AGENDA

La Vergne Planning Commission
September 30, 2025 at 6:00 PM

Item #: 4. Site Plan – Restaurant and Retail Building at 192 & 198 Old Nashville Highway – Existing and Proposed Buildings of 15,521 Square Feet on 1.35 Acres. Requested by Huddleston Steele. Property located at 192 & 198 Old Nashville Highway (Tax Map 15M, Group E, Parcels 4 & 5). C-2 (Highway Service) Zoning District. Property owned by Better Home, LLC.

DWG. No.	
C-2.1	
SCALE:	NOTED
CADFILE: C:\S\K\Kadomatsu\Tosha_2011\04	
JOB No.	REV.

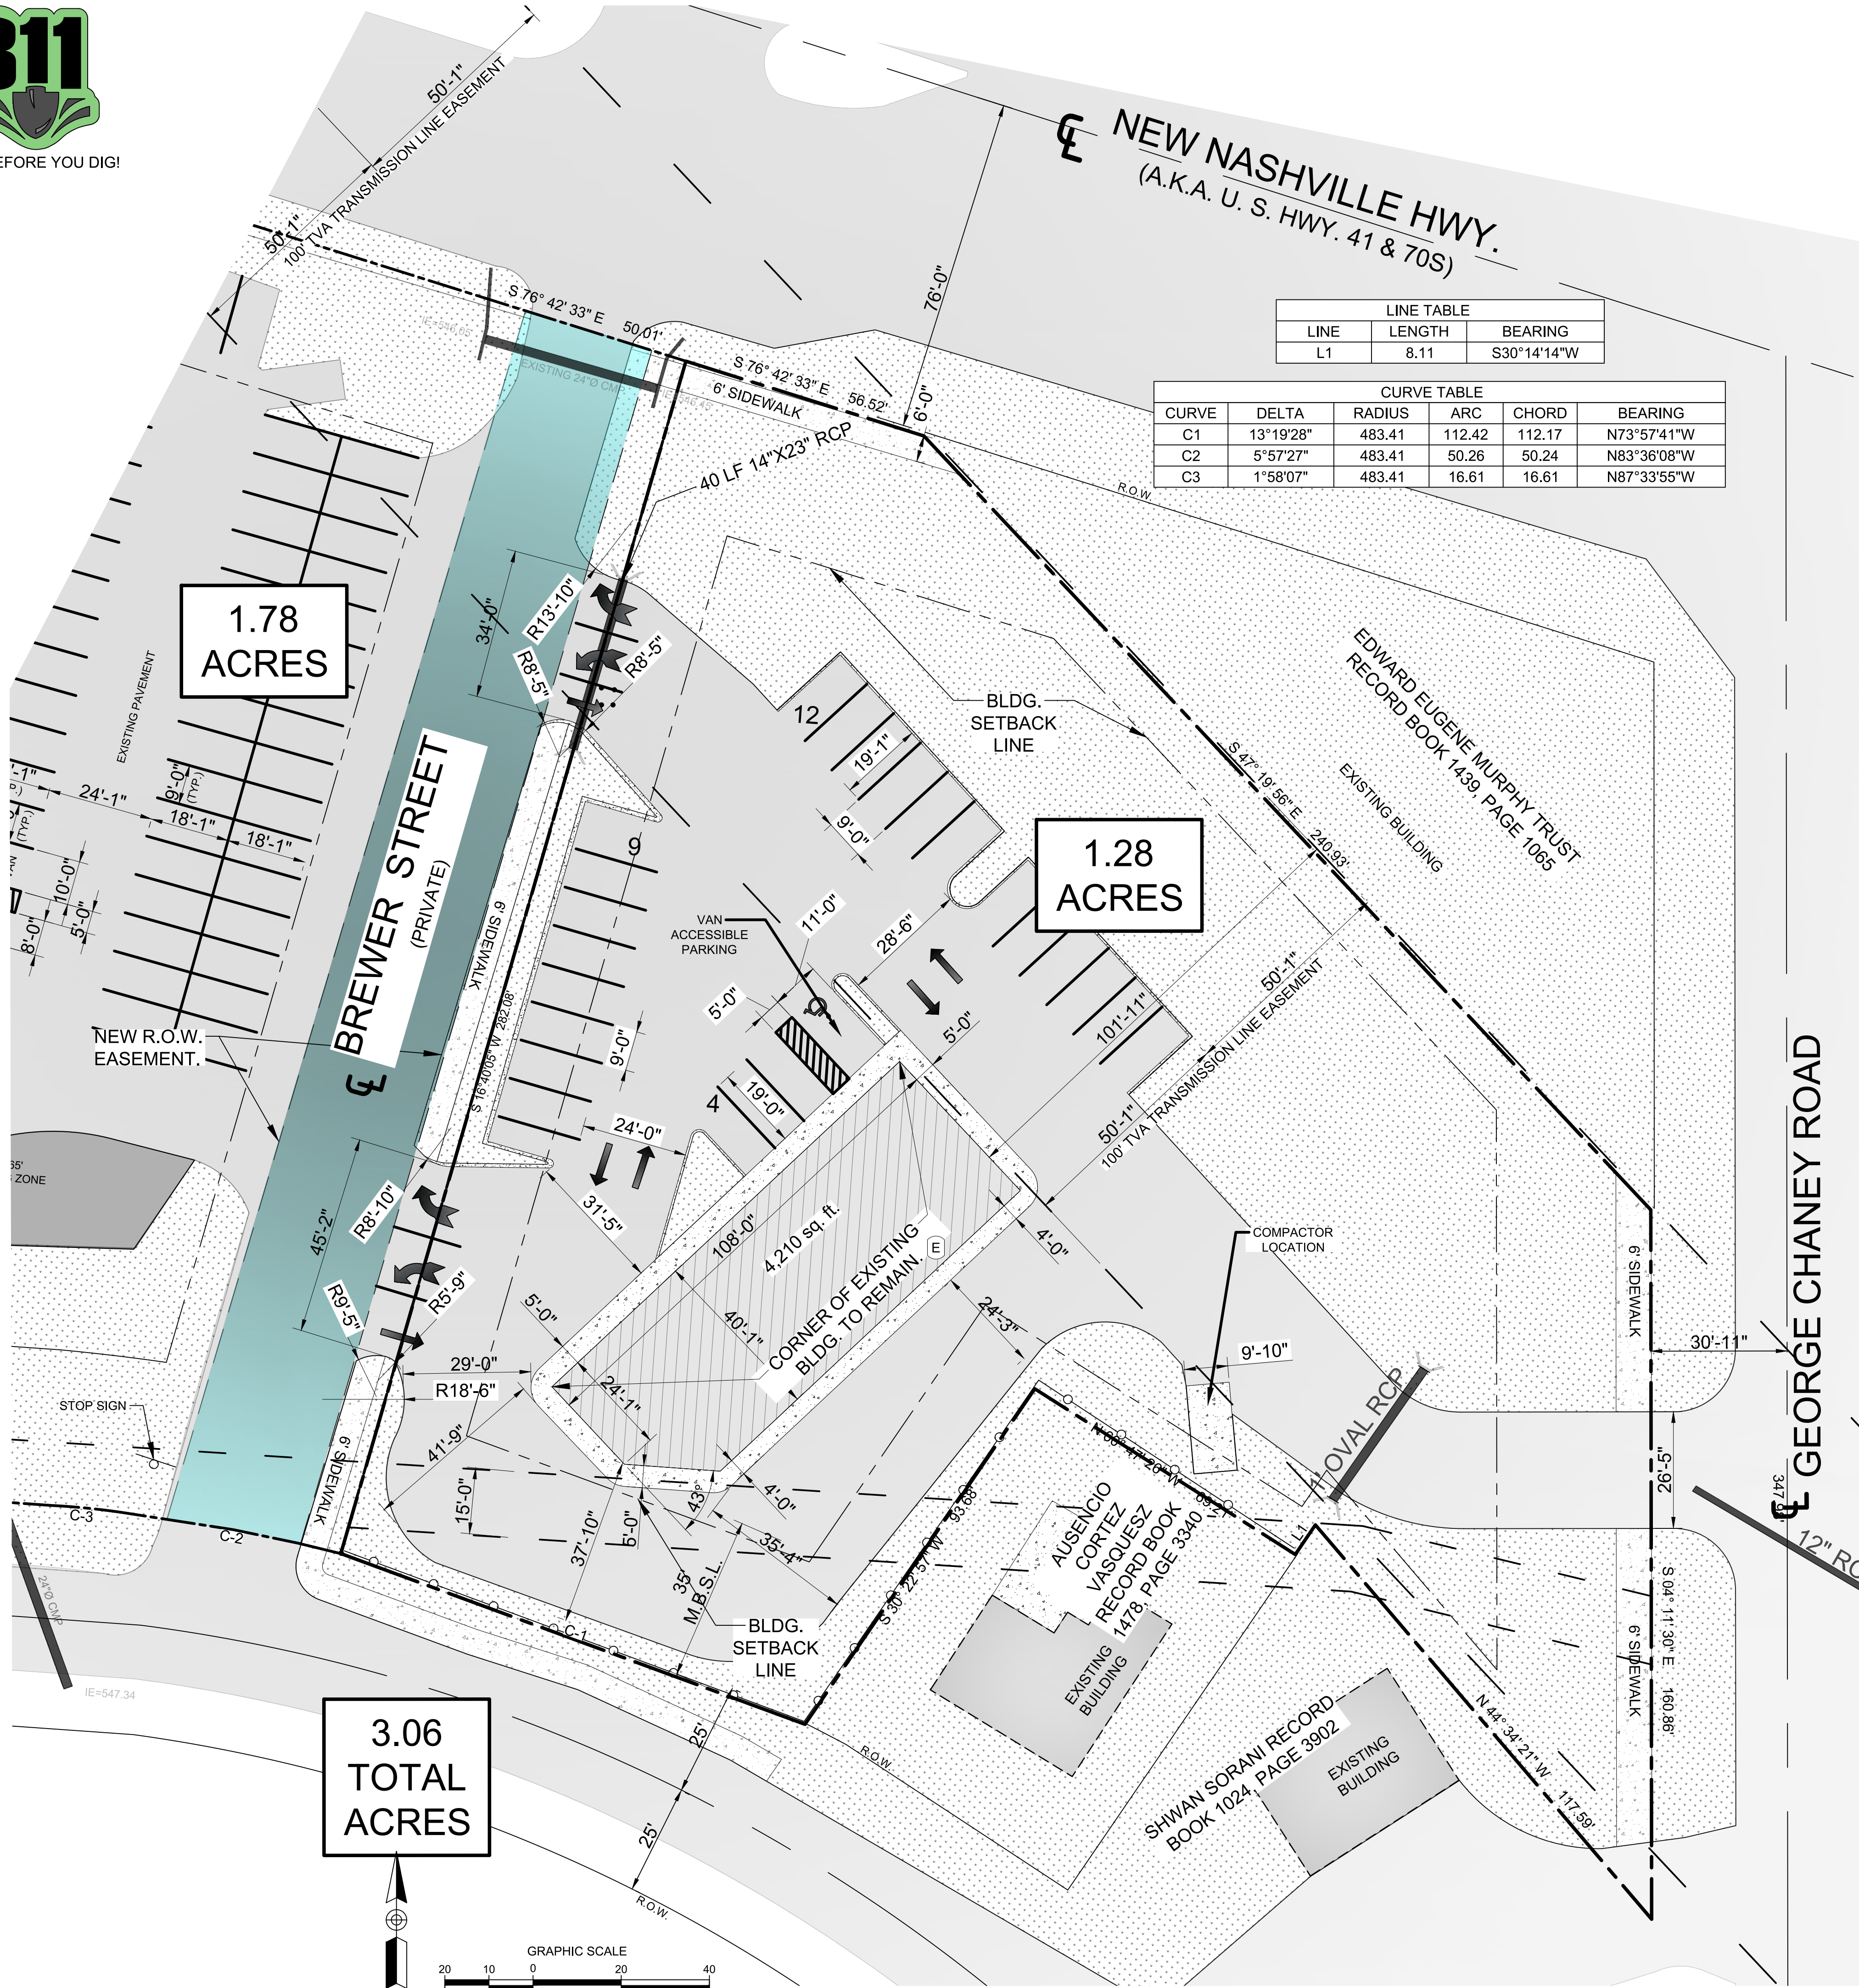
1. (Sheet C-2.1b) Comments on grading plan:

b. Show location(s) of curb ramp(s) (per detail on Sheet C-6.0).

c. Show locations of curb cuts (detail on Sheet C-6.0)

e. Show invert elevations for oval RCP and 14"x23" RCP.

SHEET NO. C1.01

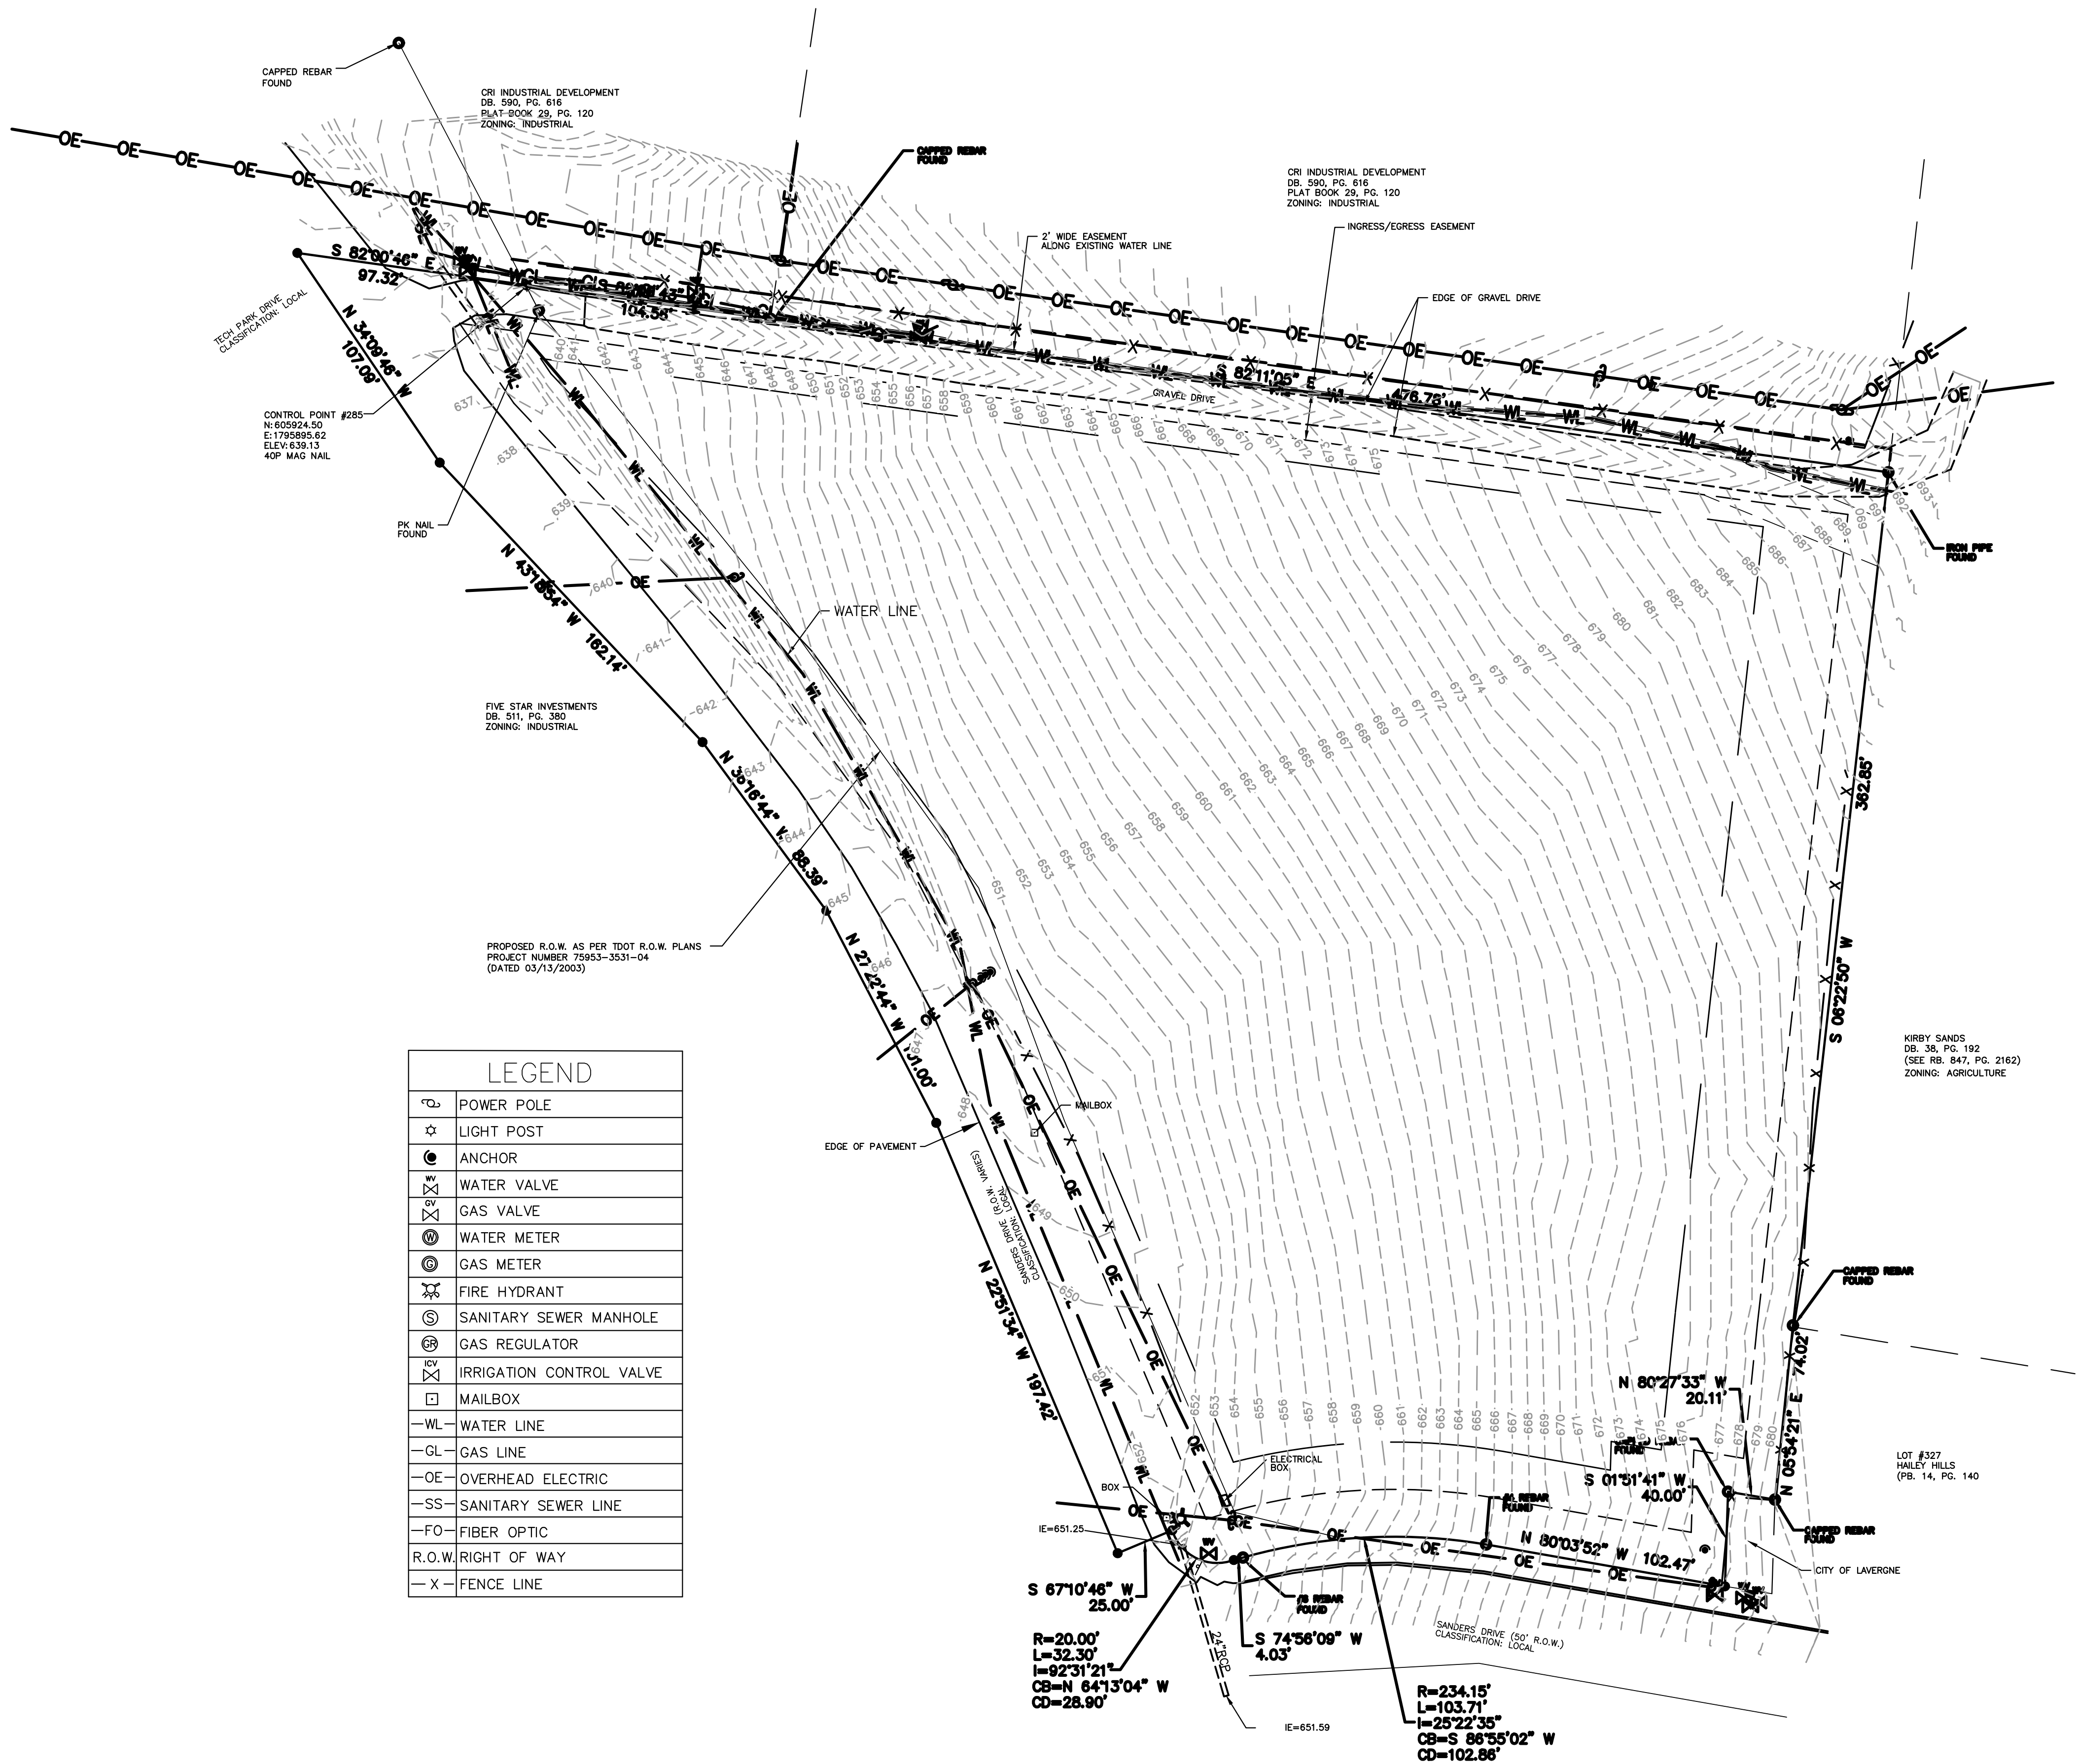
1. (Sheet C1.01) Staff recommends that applicant dedicate additional Public Utility and Drainage Easement (PUDE) as described in the Utilities section below.

2. (Sheet C1.01) Add DB 291 PG 475 for 2' waterline easement along north boundary.
3. (Sheet C1.01) Staff recommends that applicant dedicate sufficient land for Mason Road right-of-way

4. (Sheet C1.01) Correct scale in title block
5. Provide filled out draft of the Longterm Maintenance Agreement (LTMA) and Longterm Maintenance Plan (LTMP)

6. (Sheet C1.01) Move bearings and distances on north boundary so that they can be read.
7. (Sheet C2.01) Show distances from edge of paving to property boundaries along all boundaries.

10. (Sheet C1.01) Easement width on existing water line is shown as 2'. Show correct easement width.
11. (Sheet C1.01) Show DB and PG for easements.
12. (Sheet C1.01) Correct note where Mason Road is incorrectly labeled as Sanders Road.

43. (Sheet C1.01) Show tree masses.
44. (Sheet C1.01) Show areas where slopes exceed 12% and show USDA-NRCS soil types for those areas.
45. Provide a Site Profile that runs from their northwest corner of the site running southwest through the building and down to the centerline of Mason Road.
